From: Dick Lange, Building Inspector/Plan Reviewer, P.E. *D.L.*  
Mark McLocklin, Ordinance Inspector *m.m.*  
To: Jim Breuckman, Planning Department  
Date: September 23, 2013  
Re: 879 W. Auburn Rd./ Islamic Mosque Addition Review #3, 15-34-101-045, 009, 010, 011,  
City File #79-951.6

From: William Cooke, Lieutenant/Inspector  
To: Planning Department  
Date: September 25, 2013  
Re: Islamic Mosque Addition

From: Jason Boughton *JB*  
To: Jim Breuckman  
Date: September 30, 2013  
Re: Islamic Mosque Addition, City File #79-951.6, Section #34  
Site Plan Review #3

From: Gerald Lee  
To: James Breuckman  
Date: September 24, 2013  
Re: Islamic Mosque Addition  
File No. 79-951.6

Rochester Hills Truck 1  
 SCALE 1"=20' [1:240]

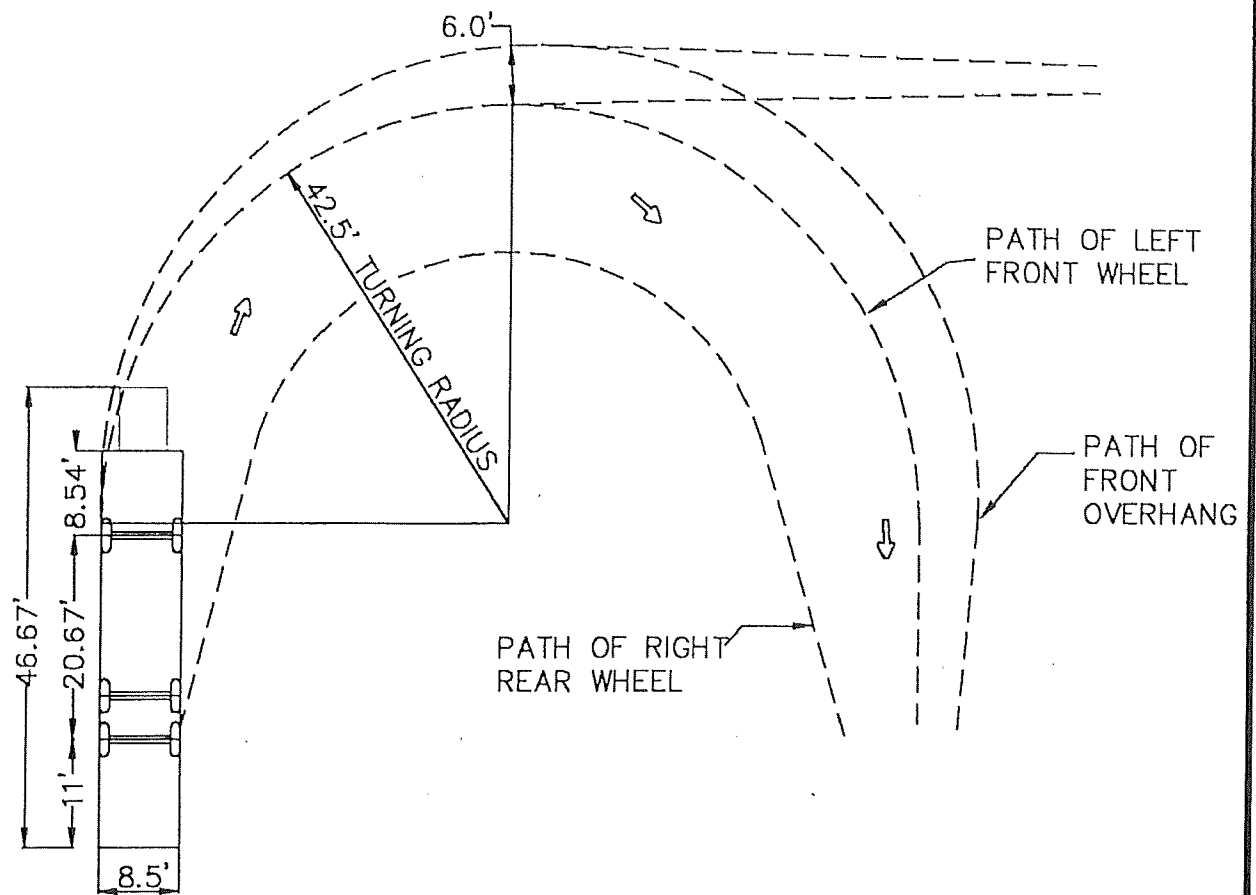
2. It appears the reconfiguration of the west approach from Auburn Road has effected fire apparatus maneuverability, specifically when traveling west along the north drive, turning north into the approach. Please verify this turn is accessible utilizing the minimum approved turning radius dimensions. See attached document for fire apparatus minimum turning radius requirements.
